SIGAR Inspection 13-10

## Bathkhak School: Unauthorized Contract Design Changes and Poor Construction Could Compromise Structural Integrity

JULY  
2013

Figure 1 - Location of Earthquakes in Afghanistan since 1964

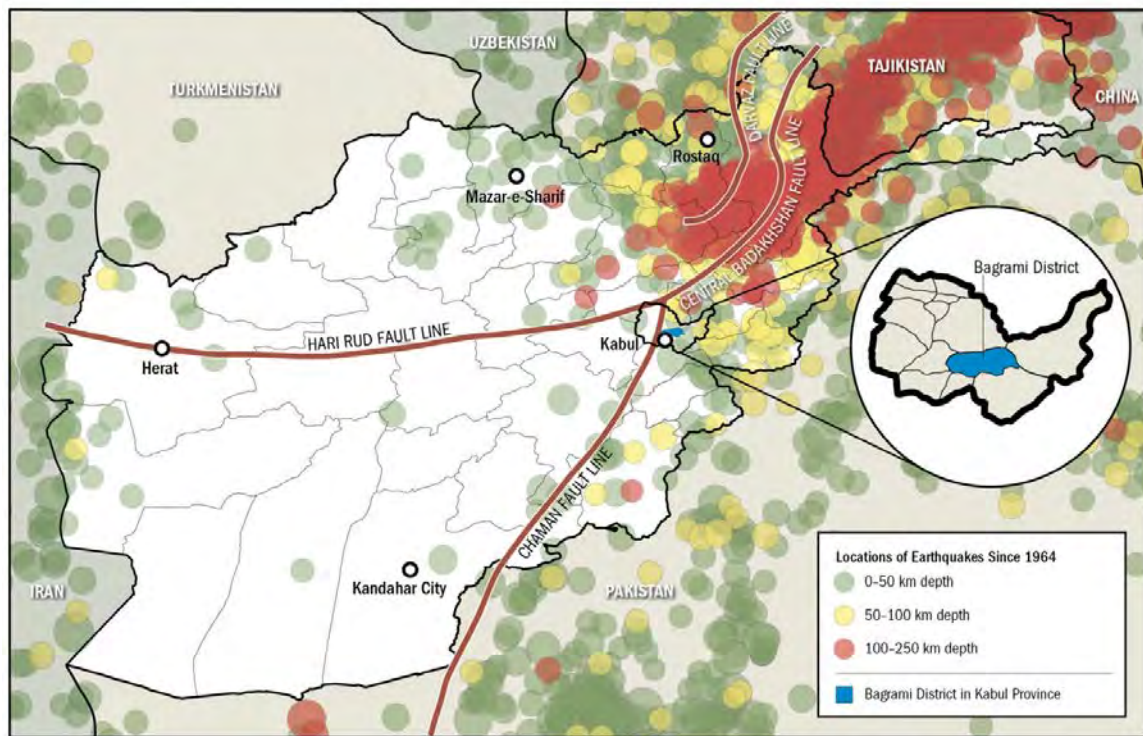
Emaar Emarat Construction Company's change from the requirement for a wood-trussed roof framing system to a flat reinforced concrete ceiling/roof without the contracting officer's approval or adequate oversight raises very serious safety concerns. Kabul province is located in an area of Afghanistan that experiences relatively frequent and intense seismic events. According to the U.S. Embassy in Afghanistan, the area surrounding Kabul has been the site of numerous shallow earthquakes (less than 50 kilometers in depth) due to its proximity to a seismic fault line that runs through the Hindu Kush Mountain Region and along the Chaman fault system.<sup>6</sup> The U.S. Geological Survey has reported that earthquakes represent a serious threat to the people and institutions of Afghanistan and have killed more than 7,000 Afghans from 1997 to 2007.<sup>7</sup> Figure 1 shows the Chaman, Hari Rud, Central Badakhshan, and Darvaz fault lines and the location of earthquakes that have occurred in Afghanistan since 1964.

**Photo 4 - Concrete Ceiling/Roof Showing Poor Workmanship**

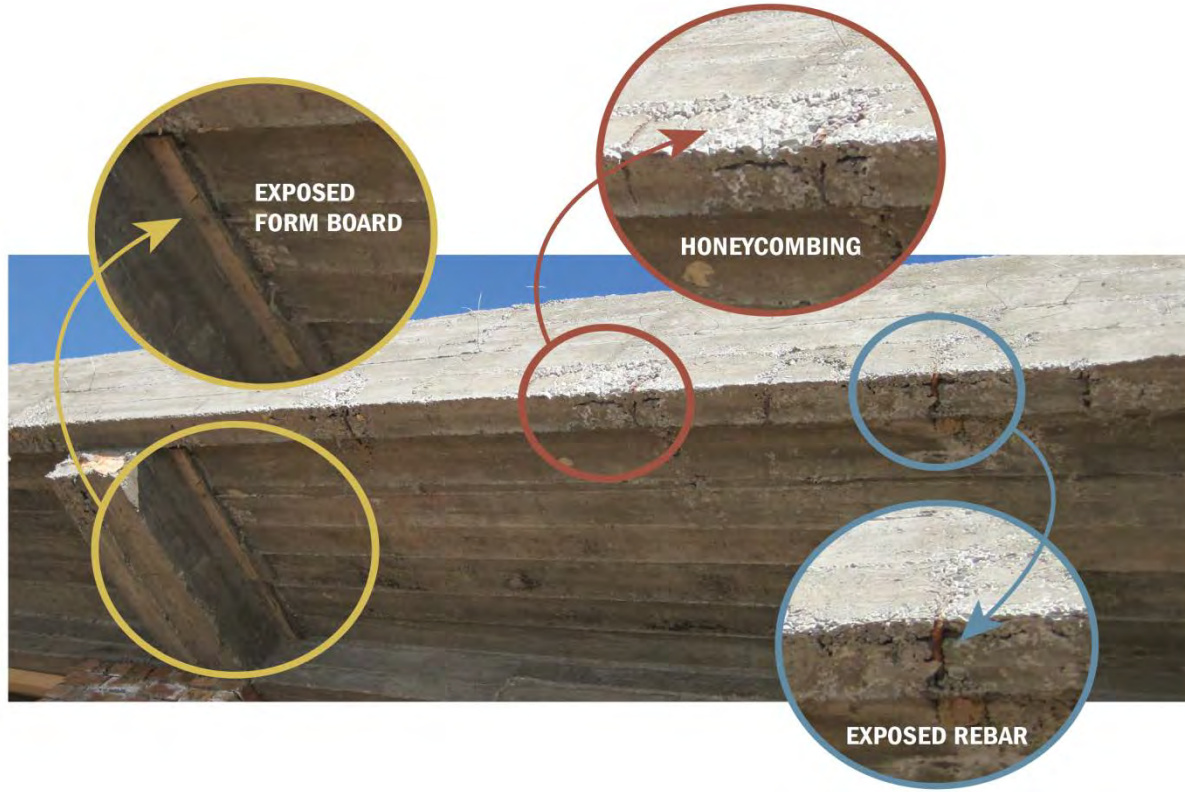
Our engineer examined the concrete roof and structural components and noted three areas of poor workmanship: (1) honeycombing, also known as "rock pockets," in the set concrete; (2) exposed rebar; and (3) concrete form boards that had not been removed before the

concrete hardened. Honeycombing is evidence of poor concrete consolidation, which may be caused by too dry a mix, incorrect aggregate size relative to the rebar's clearance, or inadequate vibration during pouring of the concrete leaving air bubbles in the concrete mix.<sup>10</sup> Depending on the location of these defects, honeycombing can significantly weaken the structure. Exposed rebar will eventually rust and compromise the integrity of the concrete and cause it to fail.<sup>11</sup> Lastly, the concrete form boards, which should have been removed, will eventually rot, leaving a space between the roof and the supporting beams, which will weaken the overall structure (see photo 4).
